From: Niranjan Vescio [nvescio@stronggo.com]
Sent: Wednesday, June 02, 2010 11:33 AM
To: 'Jesse Gonzales'; 'Robert Herz - MCDOTX'
Cc: Gordon Tyus
Subject: MAG Detectable Warning Specification
Attachments: Edit to 09-13 - Niranjan Vescio (StrongGo).pdf

Detectable warnings (DW) have been discussed at recent MAG meetings in connection with Cases 09-13 and 09-14. We addressed the Access Board's allowance for setbacks and their strong preference for dome alignment wherever possible. A matter that has been raised, but never taken up formally is the development and adoption of a DW performance/quality specification by MAG.

DETAIL NO. 232	MARICOPA ASSOCIATION of GOVERNMENTS	STANDARD DETAIL ENGLISH	CURB RAMP -TYPE 'B'	CASE 09-14 REV 4/07/2010	REVISED 01-01-2011	DETAIL NO. 232
--------------------------	--	--------------------------------	----------------------------	--------------------------	-----------------------	--------------------------

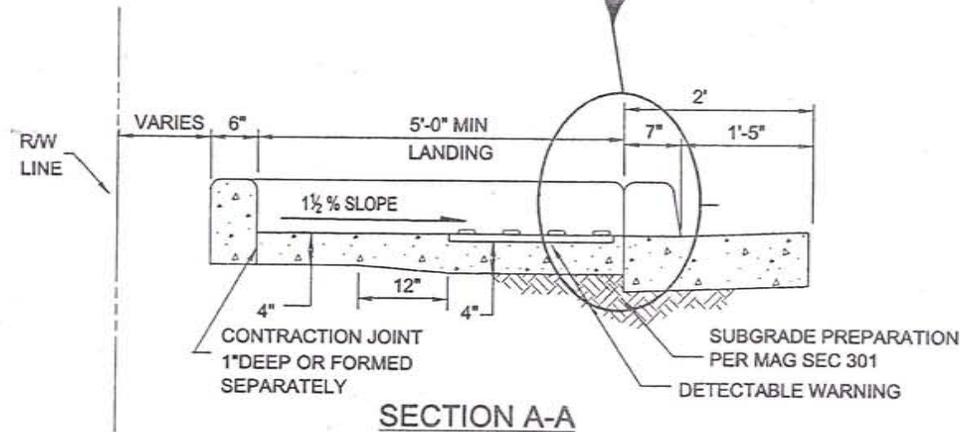
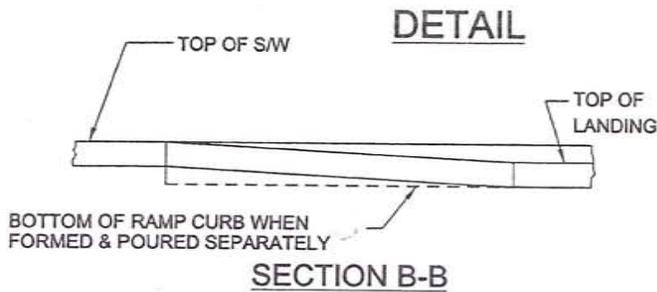
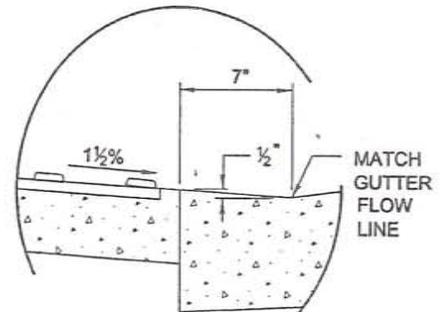
At a future MAG meeting, I would be happy to introduce the MVR specification or one drafted for MAG as a "strawman" that could then be modified to suit varied interests. In the interim, I suggest the 09-13 ramp detail currently out for comment be augmented (as attached) to allow for the development and adoption of a DW performance specification. I am sorry I cannot be present at today's meeting to introduce this matter in person. I trust that this e-mail to you, copying, Gordon Tyus will serve in my absence.

MAG DW SPECIFICATION OR

1. CLASS 'B' CONCRETE CONSTRUCTION PER SECTION 725.
2. DETECTABLE WARNING IS TO COMPLY WITH THE JURISDICTIONAL AGENCY'S REQUIREMENT.
3. RAMP LONGITUDINAL SLOPE SHALL BE 12:1 OR FLATTER.
4. RAMP CROSS SLOPE SHALL BE 1½%.
